OHIO TURNPIKE AND
INFRASTRUCTURE COMMISSION

ADDENDUM NO. 1

CONTRACT NO. 39-14-02

RIGHT TWO (2) LANES AND SHOULDER RECONSTRUCTION
MILEPOST 159.80 TO MILEPOST 164.82
CUYAHOGA COUNTY, OHIO

MOT TYPICAL SECTION (EB LANES CONSTRUCTION) - PHASE 2A

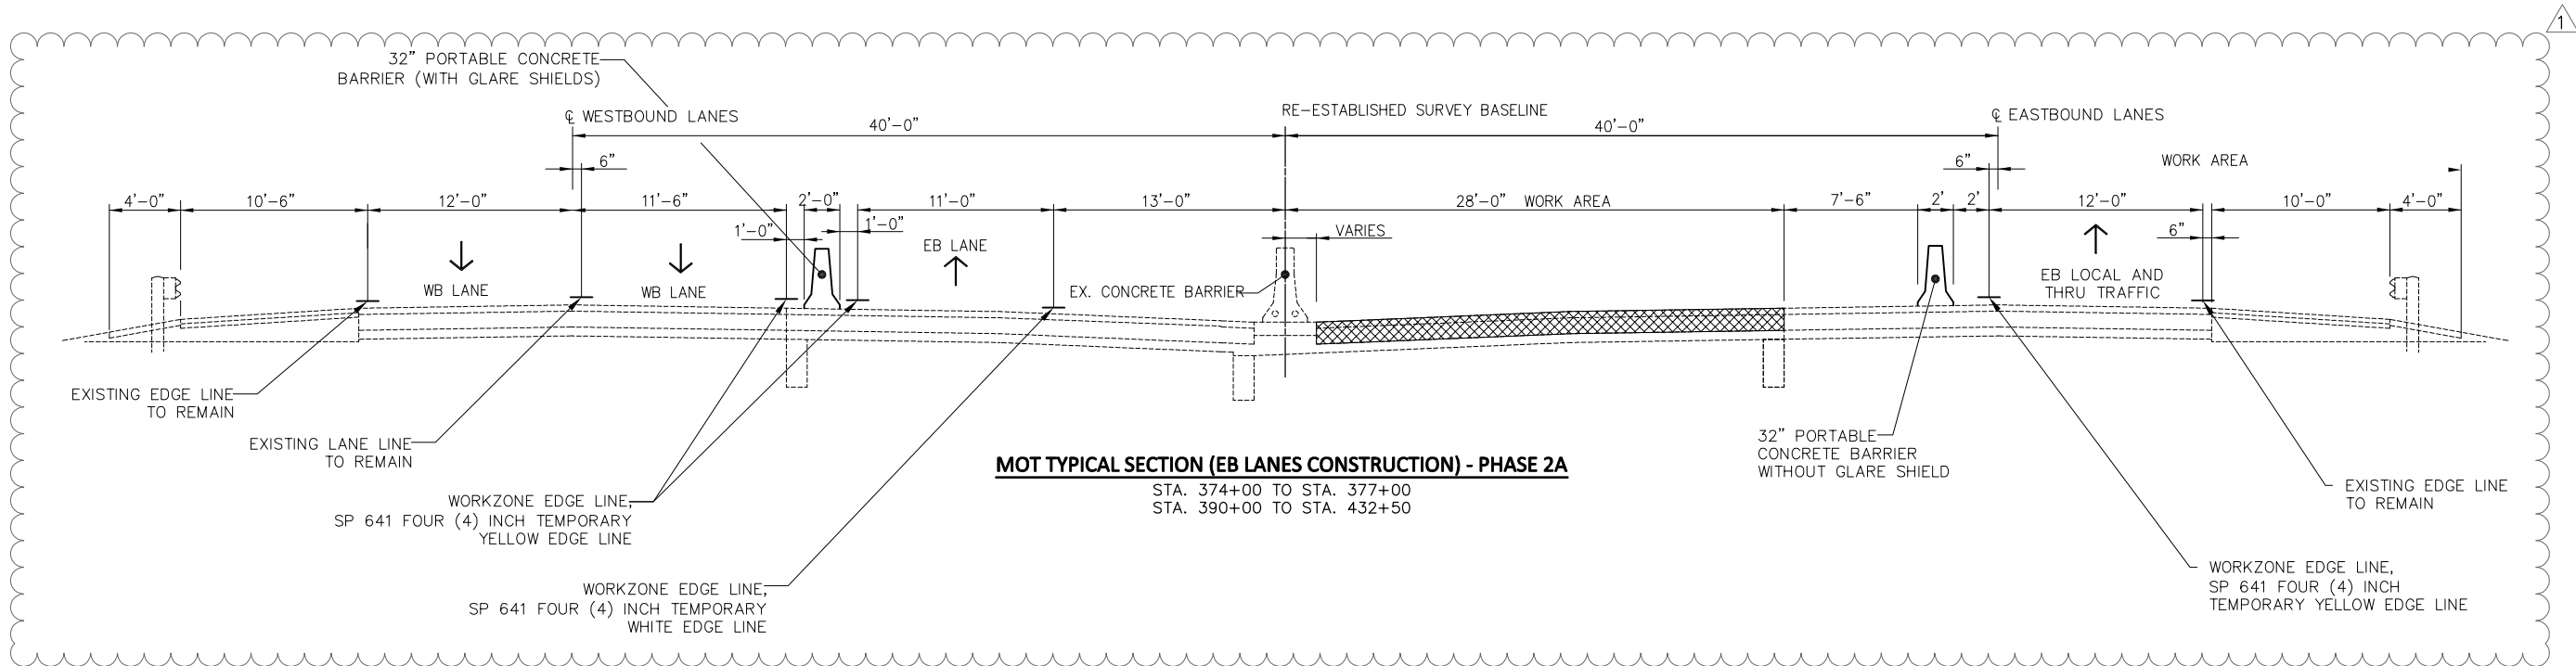
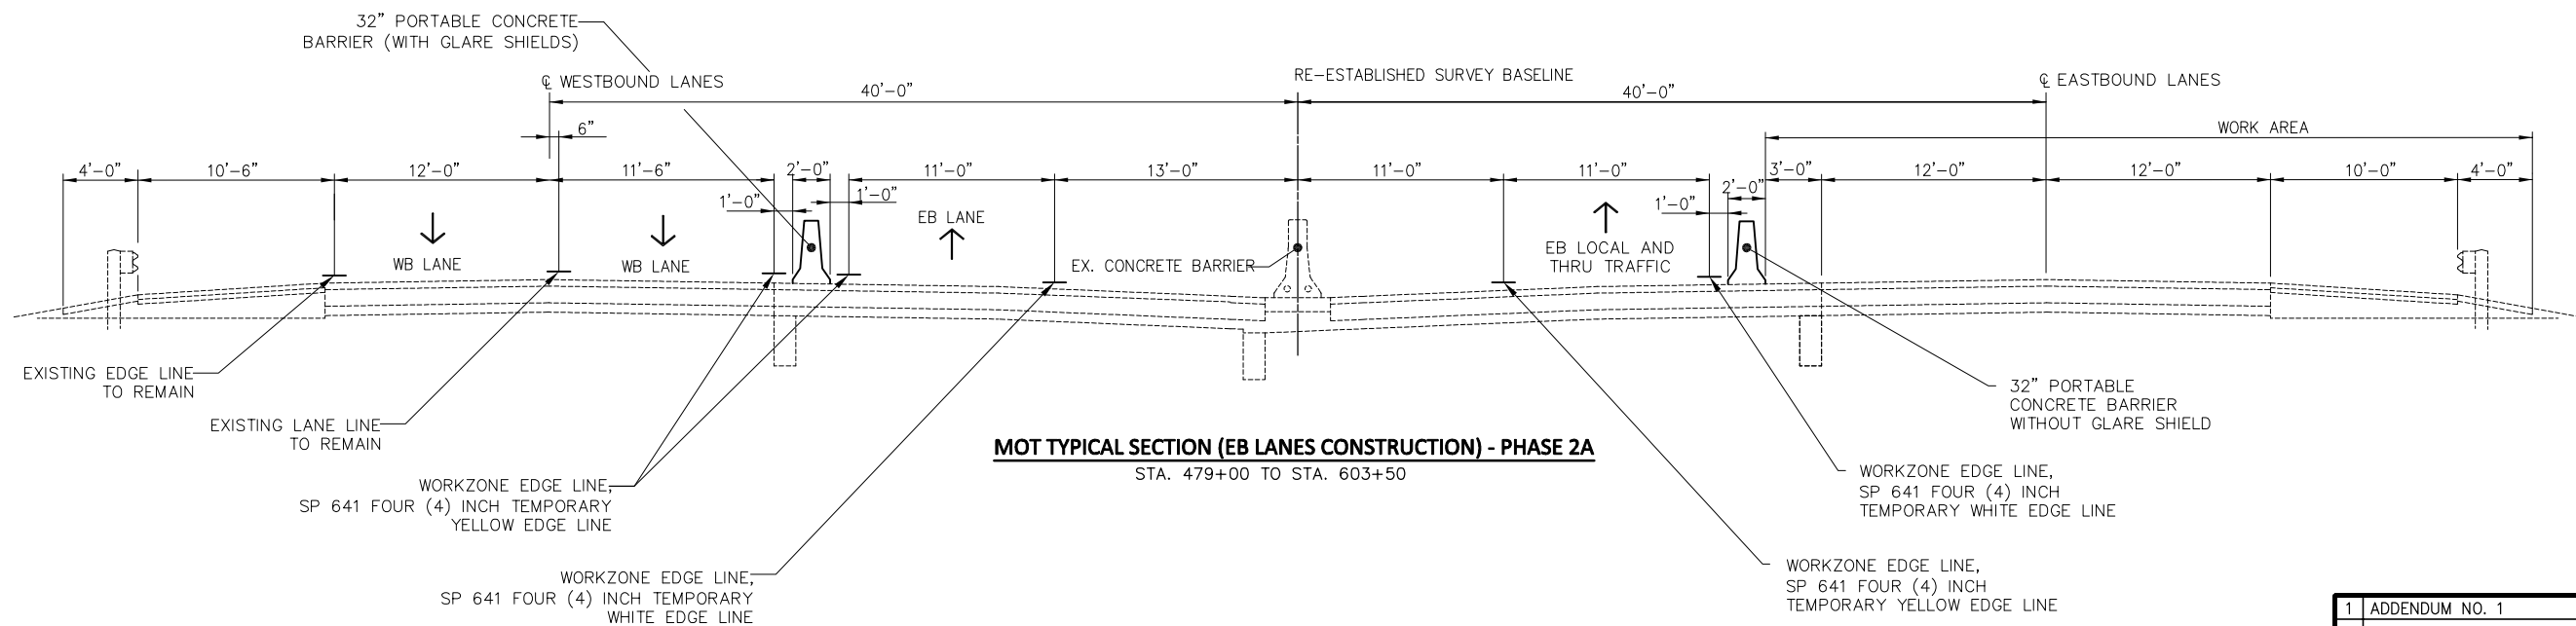
Q#2 Sheet 20 of 414 states that during Phase 2A, traffic will be placed contra-flow with one EB local/thru traffic lane on the EB outside lane such that inside pavement/approach slab replacements can be performed. The MOT typical section on sheet 43 shows the EB local/thru lane on the EB inside lane with no work being performed, contrary to the note on sheet 20. It appears that this drawing on sheet 43 is in error. Is that correct? If so, please modify the drawing to reflect the actual intended traffic configuration for Phase 2A.

Q#5 MOT Typical sections provided for both phase 2A & 3A are incorrect, please revise to match the desired traffic pattern in these phases.

A#2 Please refer to Maintenance of Traffic Schematic Plan Sheets 49 through 51 and Plan Sheets 82 through 86. The Work area hatch indicates the area of the Project where Phase 2A Work is anticipated to be performed. The Phase 2A MOT Typical Section, (Plan Sheet 43) is the same typical section as shown in Phase 2B (Sheet 44) minus the Work area hatch. The intentions of the Phase 2A Plans are to establish the portable barrier location that will be used throughout the Phase 2B limits of the Project. By erecting the portable barrier at the start of Phase 2 operations, the intent is to minimize the disruption to traffic by establishing a traffic pattern that will be consistently maintained east of Sta. 479+00. For further clarification, typical sections for Phase 2A and Phase 3A were added to Plan Sheets 43 and 45 via this Addendum No. 1. See below. For station ranges outside of those shown in the typical, see the MOT Plans.

OHIO TURNPIKE AND INFRASTRUCTURE COMMISSION	
CONCRETE BARRIER AT OVERHEAD BRIDGES	
DATE: JUNE 25, 2007	SCALE: N.T.S.
O.T.I.C. STANDARD DRAWING CBR-2

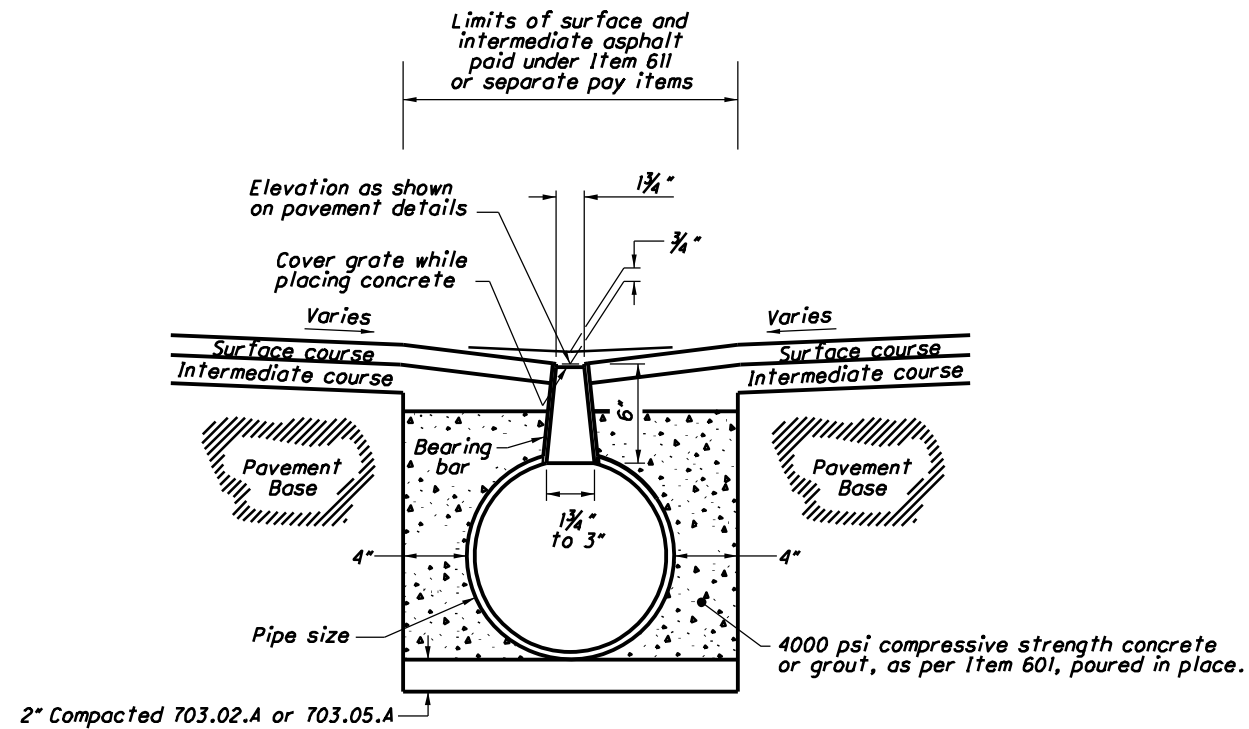
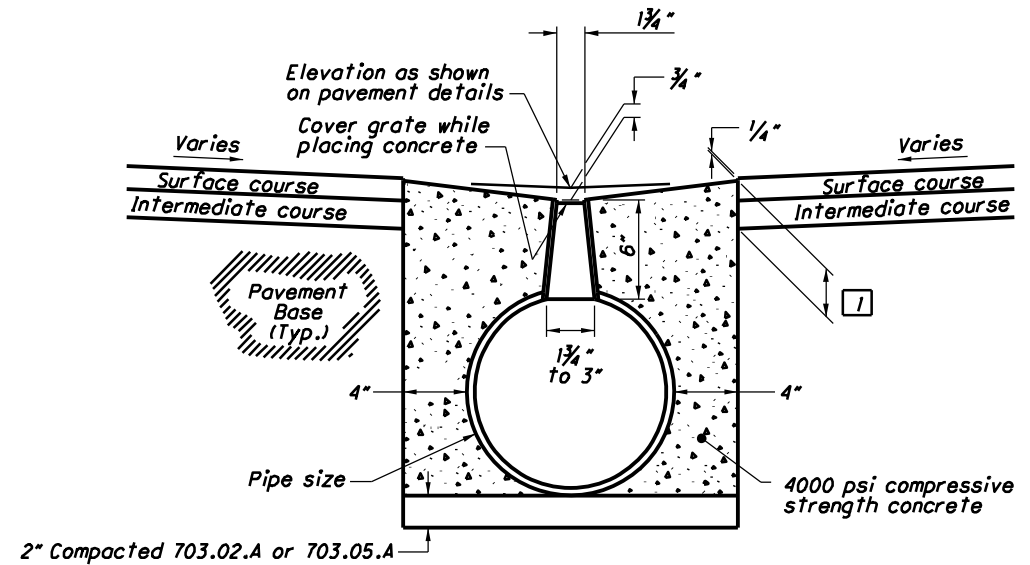
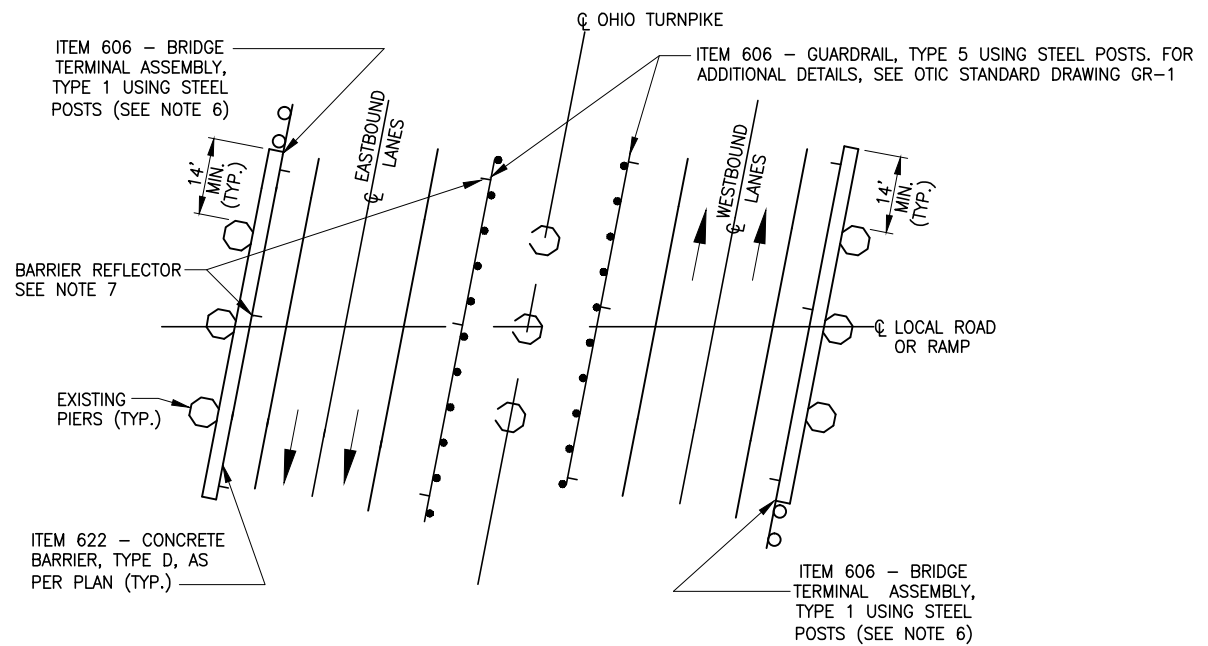
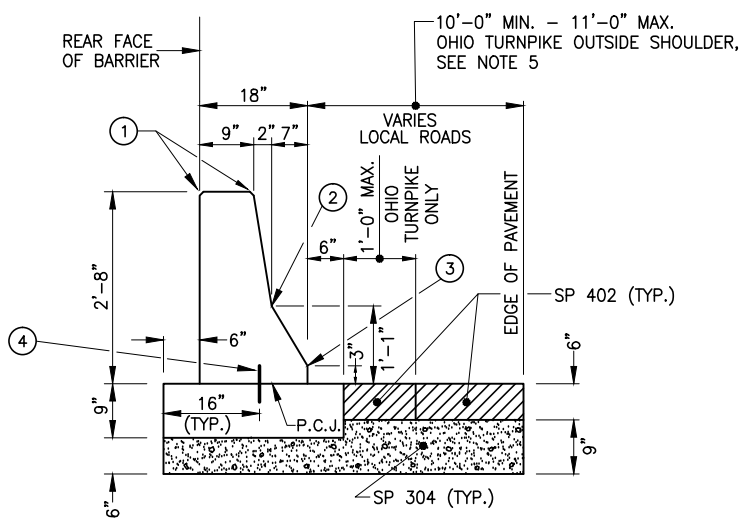
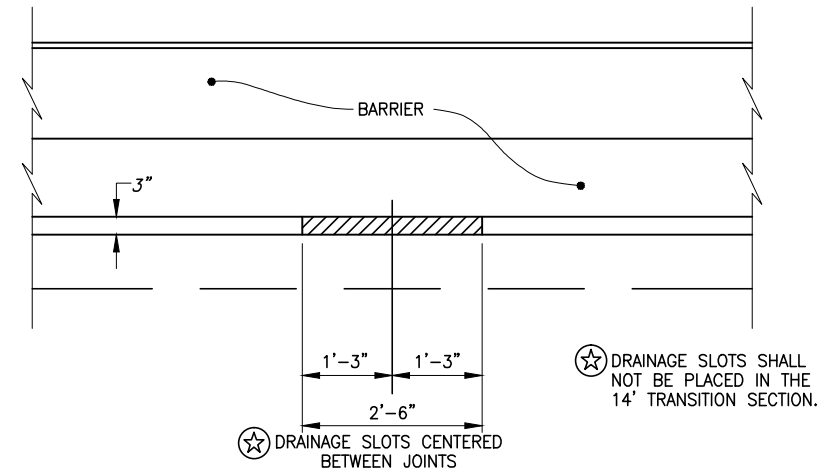
Ohio Department of Transportation Standard Construction Drawing **DM-1.3**, dated **01-18-13**, was added and incorporated via this Addendum No. 1 in the Contract Documents.
